Subject: Material for today's Light-duty GHG NPRM discussion.

Summary points from EPA review of CAFE model (NPRM version) – Effect of EPA code revisions

Meeting with Office of Management and Budget/OIRA

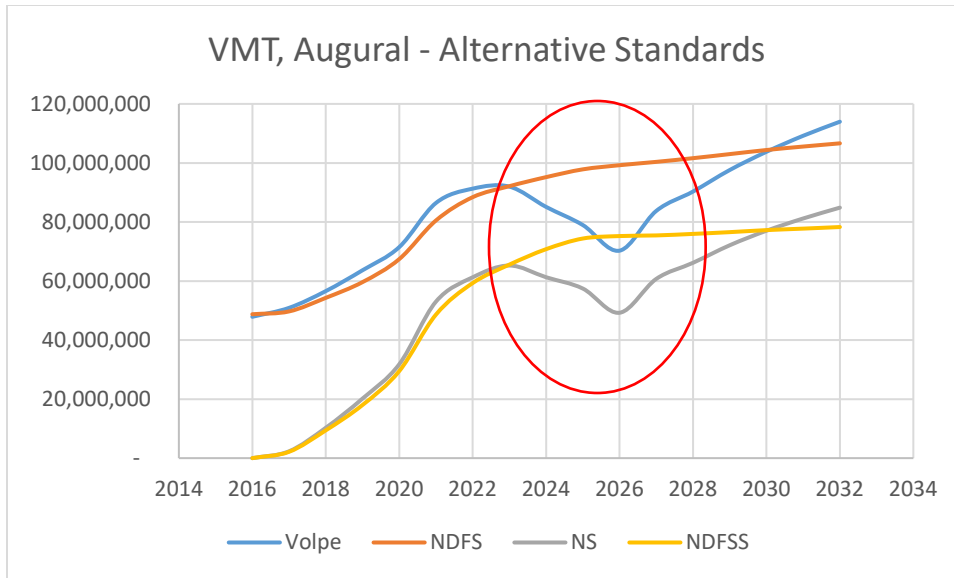
- The graph below shows differences in VMT between the Augural and Alternative standards. It finds that the change in the new vehicle fleet modeled by the DFS leads to a smaller difference in VMT during the period of the Augural or Alternative standards than before or after, although the Augural standards have a larger overall fleet, more rebound driving, and, using the DFS, a higher proportion of light trucks.

Figure 6 Incremental Effectiveness of TURBO1 to TURBO2 (MedSUV class)

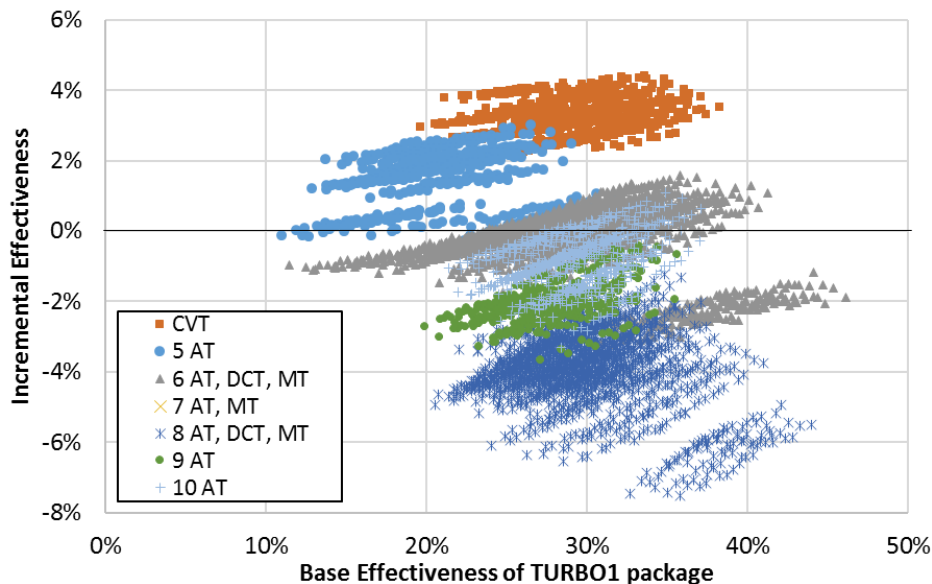
The technology inputs include two levels of turbocharged engines, TURBO1 and TURBO2. The incremental cost of TURBO2 hardware over TURBO1 hardware is about \$350 to \$700 in 2030; although it is unclear what specific technologies are represented by this cost, one would expect a generally higher effectiveness. However, depending on the package and car class, the actual incremental effectiveness values from the NHTSA technology inputs for the TURBO2 technology is often negative. The “Medium SUV” class, shown in Figure 8 has the most pronounced effect, with the addition of the TURBO2 technology, on average, having a negative effectiveness.

Figure 7 Incremental Effectiveness of TURBO2 to CEGR1 (MedCarPerf class)

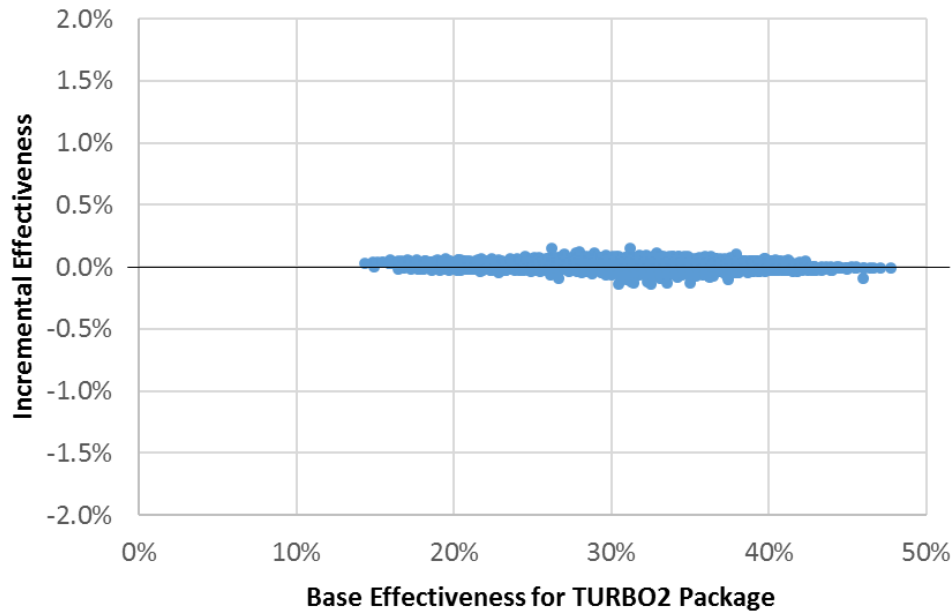
A cooled EGR package when added to the advanced turbocharged engine (TURBO2) has a cost of \$334 in 2030. Cooled EGR is a technology that has been used in the market, and has a significant effect on CO₂ reduction. However, as illustrated in Figure 9, the incremental effectiveness is at or near zero for nearly all packages (and averaging zero for all packages). The “Medium Car Performance” class shown in the figure is representative of the near-zero effect of the technology for all classes.

Figure 9: EPA Observations of Transmission Effectiveness

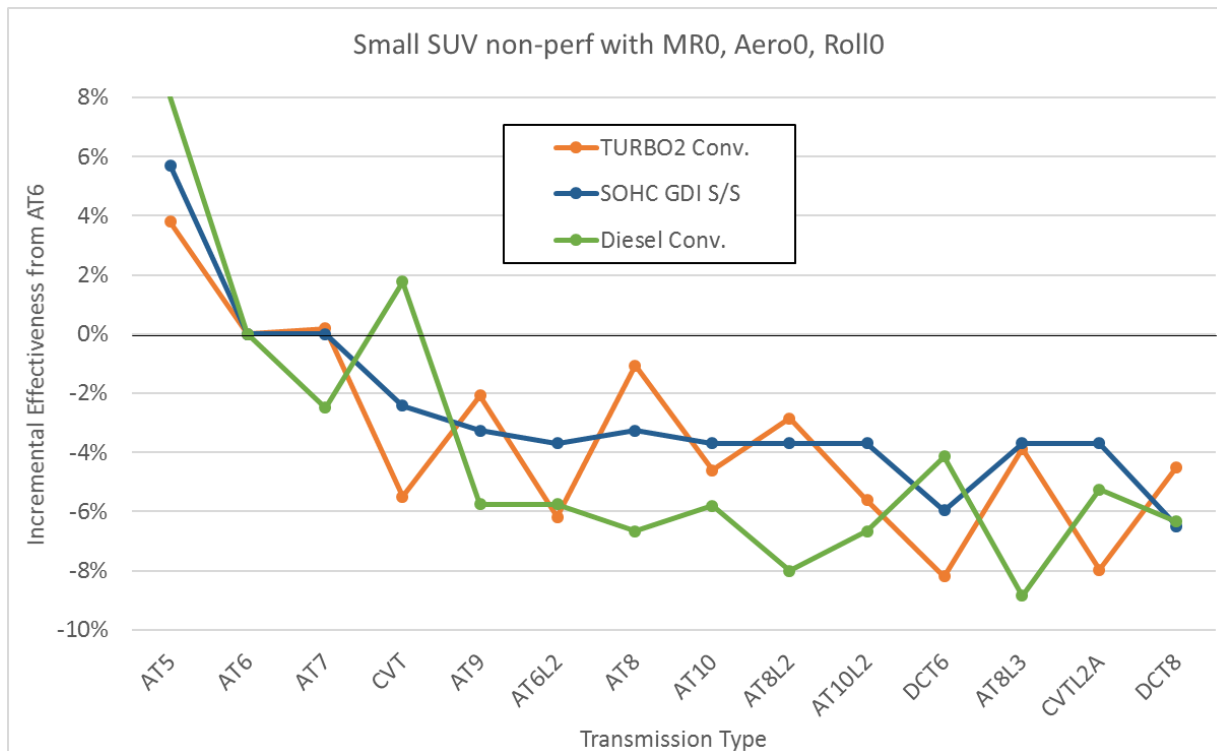
As part of the review process with NHTSA, NHTSA requested additional information and specific examples of vehicle technologies that did not follow the logical progression of transmission technology and commensurate effectiveness. In response EPA provided Figure 9: EPA observations of transmission effectiveness below. This figure shows that as advanced transmission technologies are applied to several powertrain types, there are instances where the more advanced transmission demonstrates lower effectiveness than the less advanced transmission. In addition, to this chart EPA also provided the exact technology package references from the CAFE model inputs. As of this summary, NHTSA has not yet responded to this observation.

Figure 11 Incremental Effectiveness of 48V Mild Hybrid with belt-integrated starter-generator (BISG) to crank-integrated starter-generator (CISG) (Small Car class)

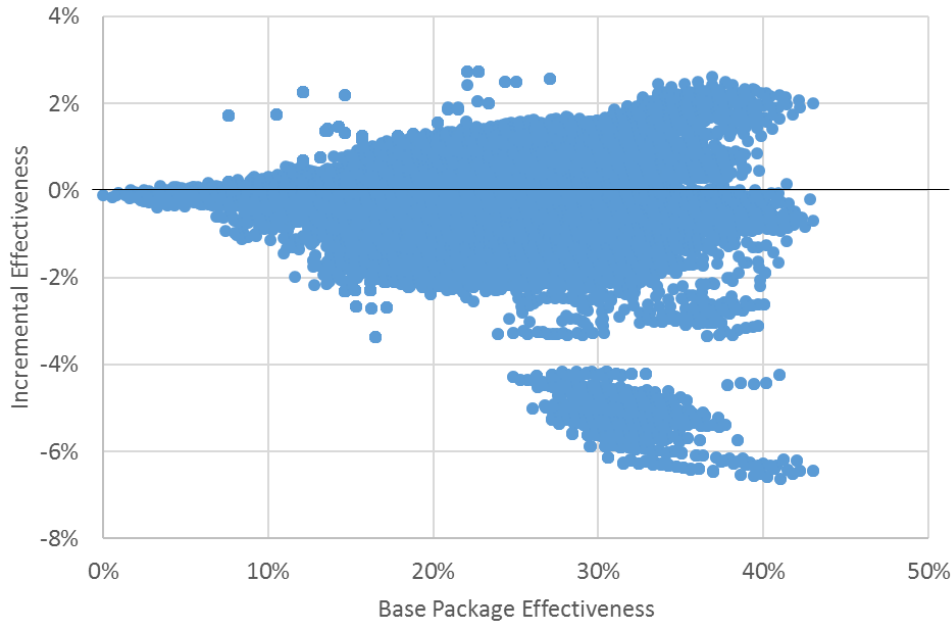
However, on average, the CISG is slightly less effective than the BISG, although with a wide spread of effectiveness. The small car example shown in Figure 12 is typical, with the incremental effectiveness of most packages between about +1% and -1%.

Figure 12: EPA’s Observations of Negative Effectiveness for Start/Stop Packages

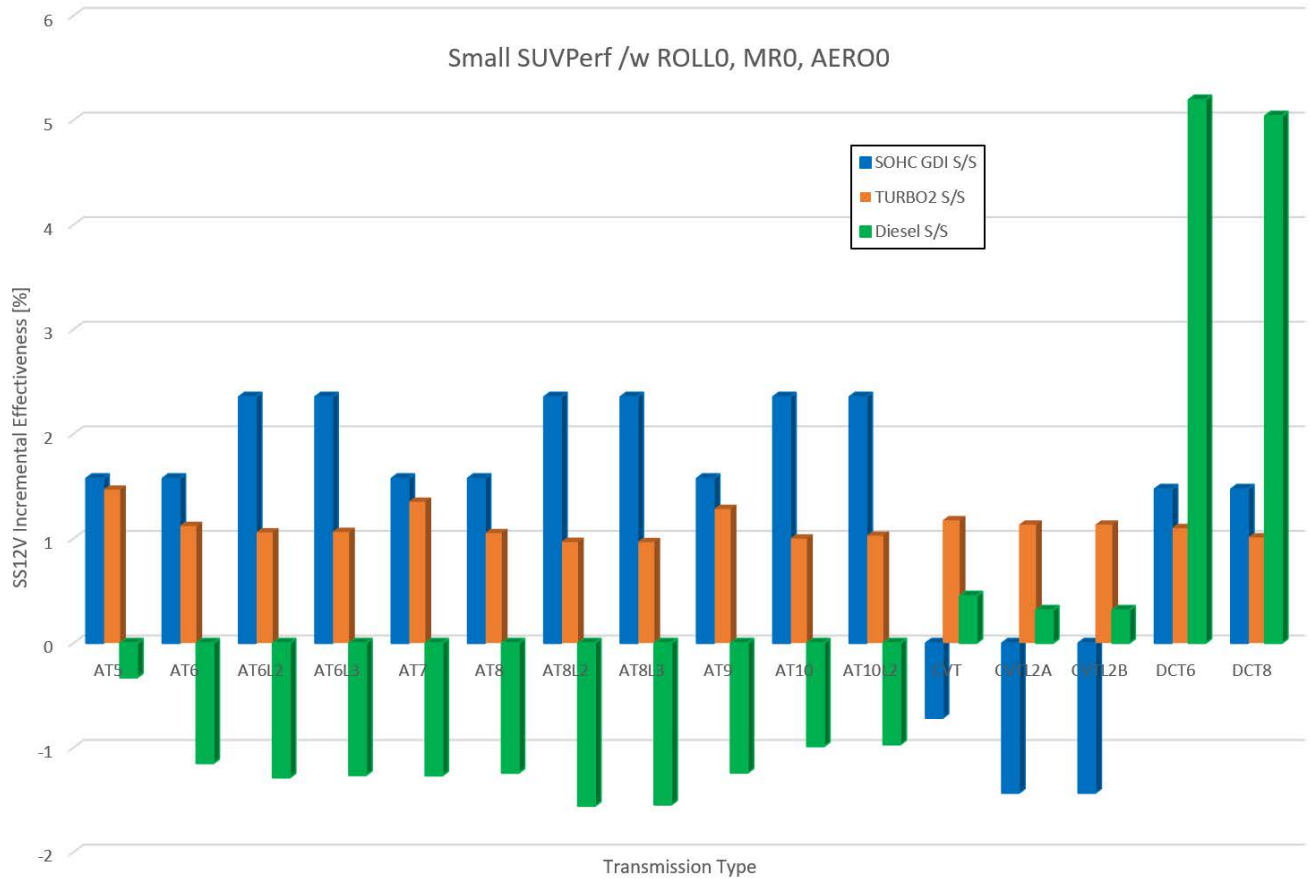
In addition to examples of unexpected transmission effectiveness estimates, NHTSA also requested examples of observed negative 12V start-stop effectiveness. In Figure 12: EPA’s Observations of Negative Effectiveness for Start/Stop Packages, below, EPA has identified 12V start/stop packages that demonstrate negative effectiveness. These results are not rational. There are not situations under which turning off the engine instead of allowing the engine to idle would result in increased fuel consumption. In addition, for those packages with the same engine and positive effectiveness, it is also unexpected to observe such large variation in start/stop effectiveness. A SOHC GDI S/S should consume the same amount of fuel at idle independent of being mated to an AT8 transmission or an AT8L2 transmission.

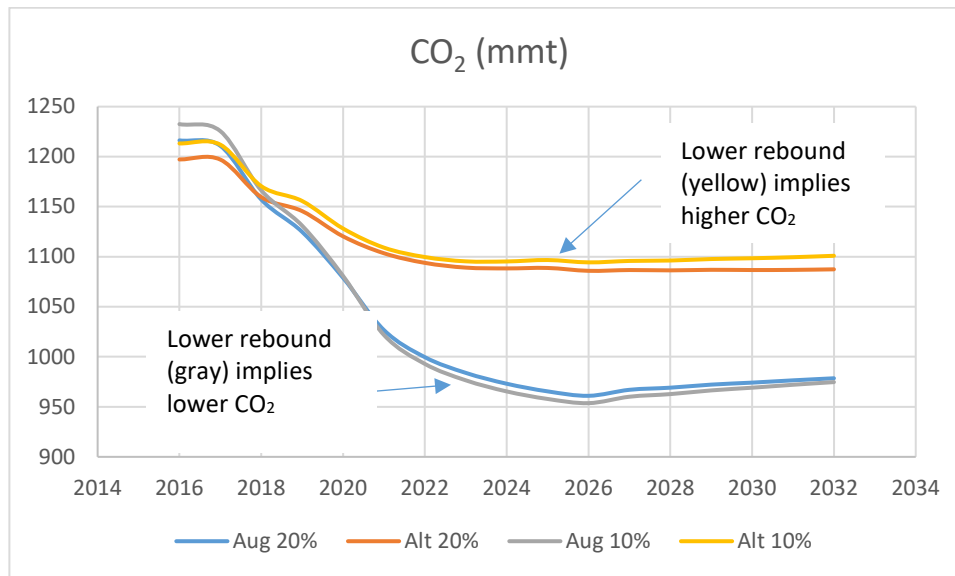
Question/Information Request 13. Can NHTSA provide an explanation for why such a dramatic decline in annual VMT occurs after age 6, and considering that large decline why does NHTSA believe that the IHS/Polk data is more defensible than multiple other sources which are based on population-weighted samples of odometer readings of individual vehicles.

Relationship between miles traveled and total fatalities

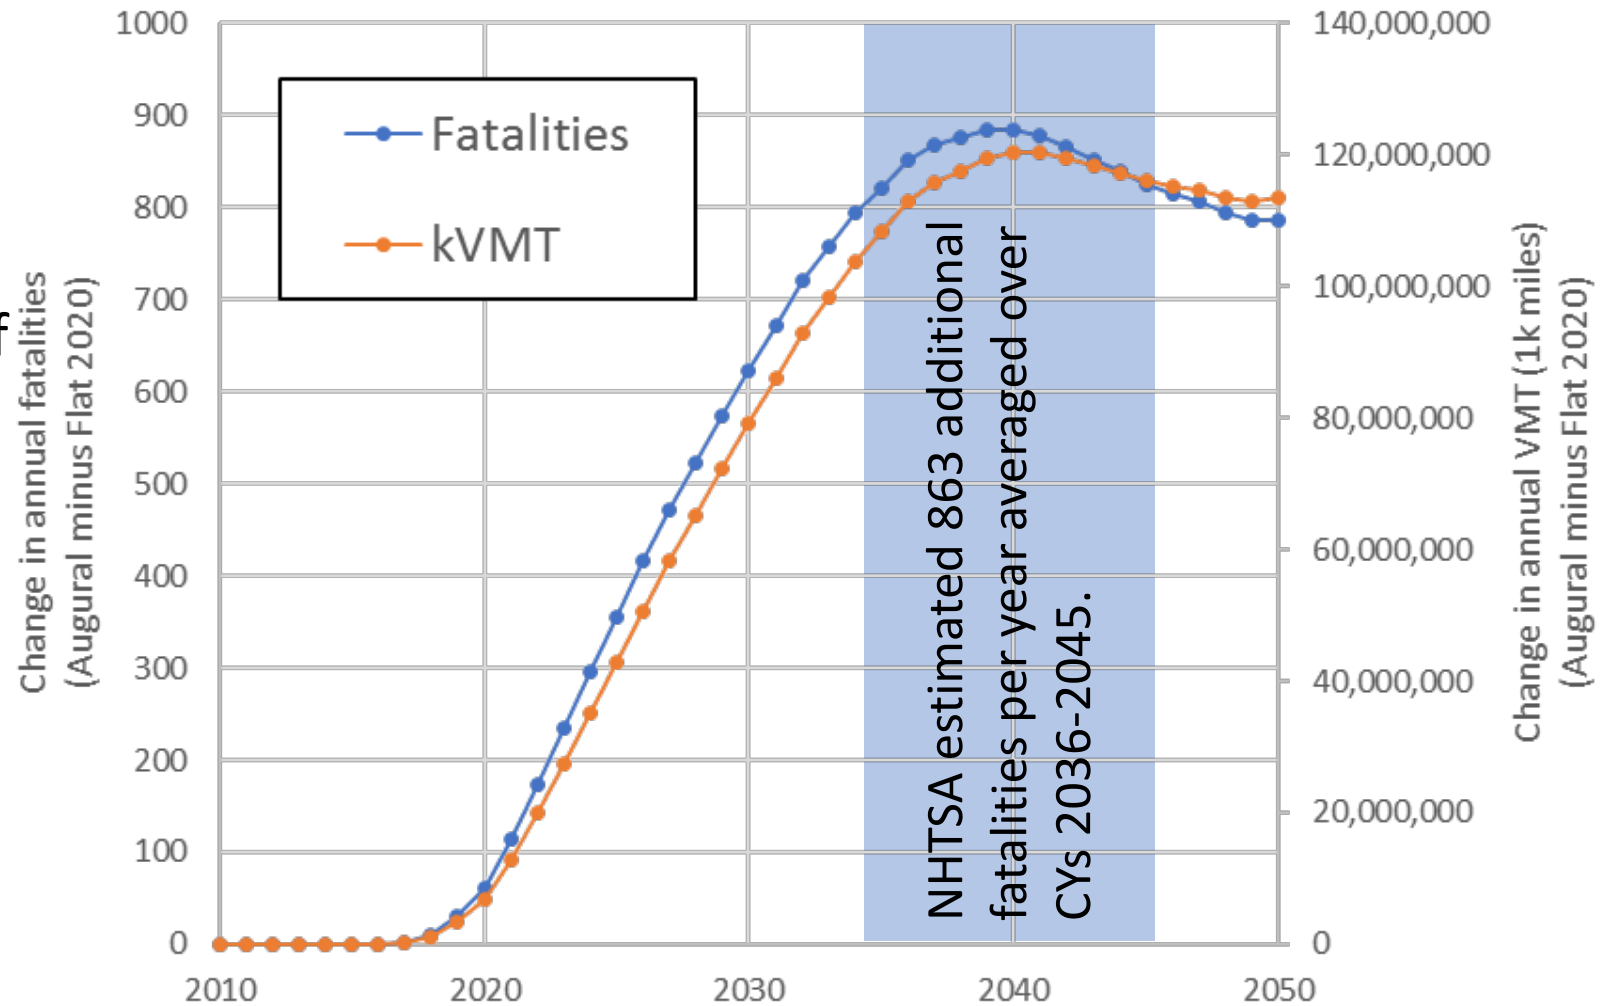
- Total fatalities are highly correlated with total VMT
- CAFE model improperly estimates the VMT impact of the Augural standards (following slides)
- The safety metric of ‘fatalities per mile’¹ is unaffected by anomalies in VMT projection, and is therefore a more reliable metric of safety for this review

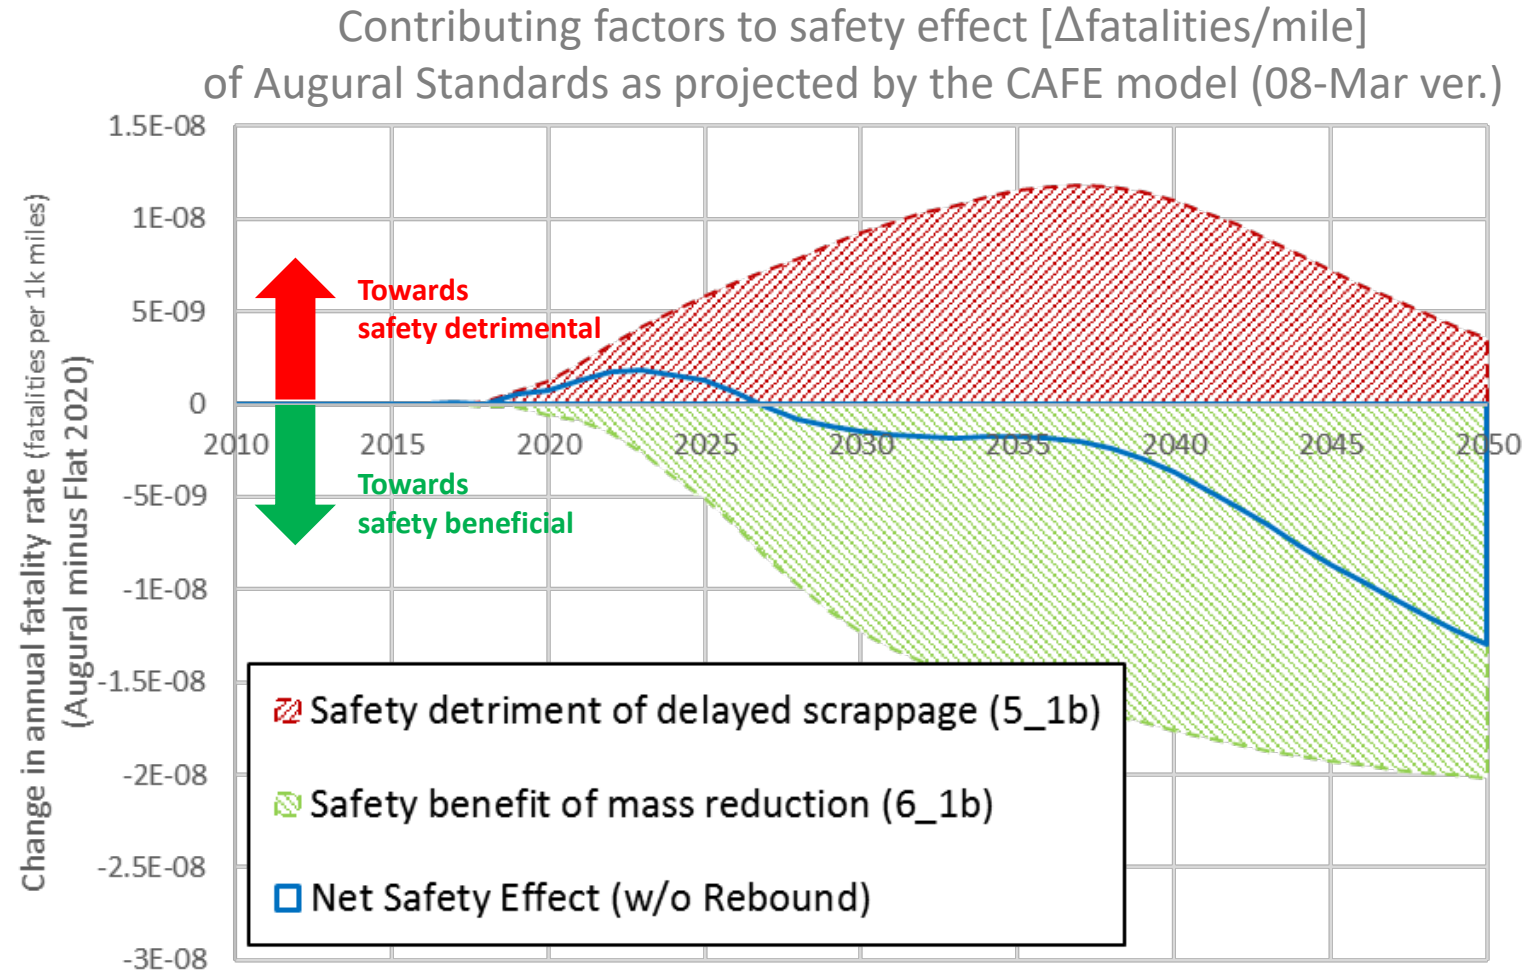
- The augural standards provide an overall safety benefit, relative to flat standards
- Mass reduction provides a safety benefit due to the greater amount of weight removed from larger vehicles (relative to smaller vehicles) and the resulting improvement in crash compatibility
- Any detriment due to delayed scrappage is more than offset by the benefit of mass reduction
- The benefit of mass reduction extends perpetually into the future, while the detriment of delayed scrappage becomes smaller over time

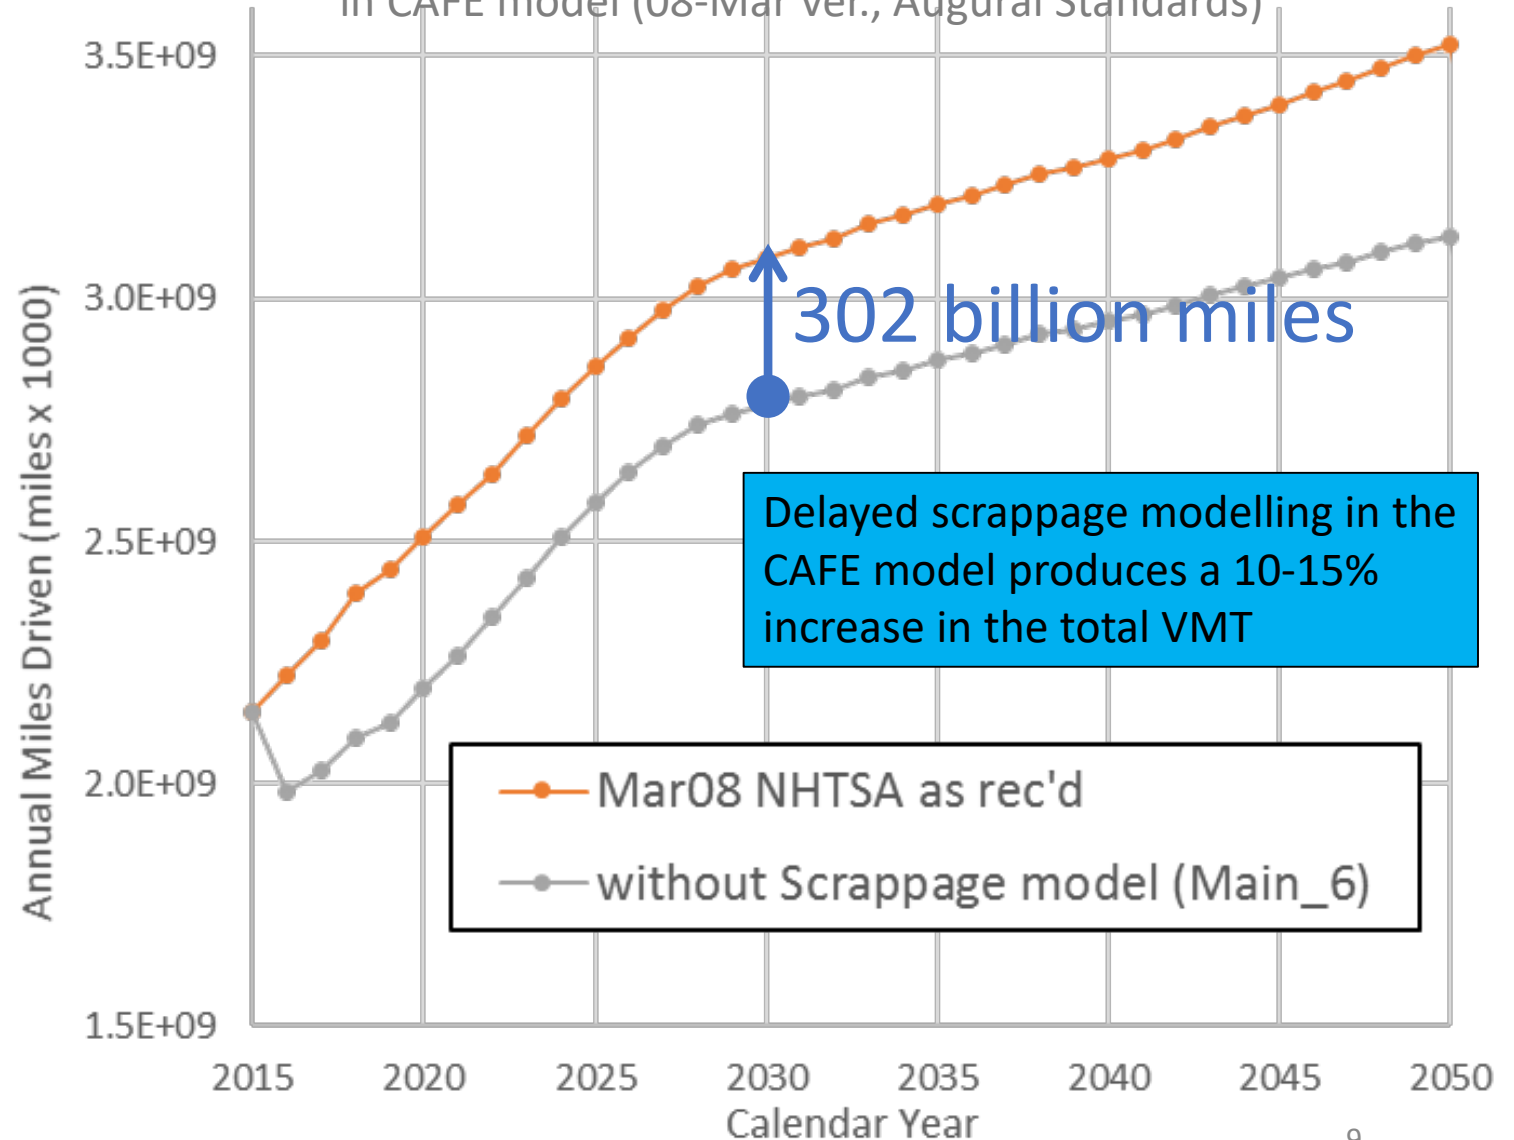
CAFE model implementation: The use of the scrappage model produces a 10-15% increase in total VMT.
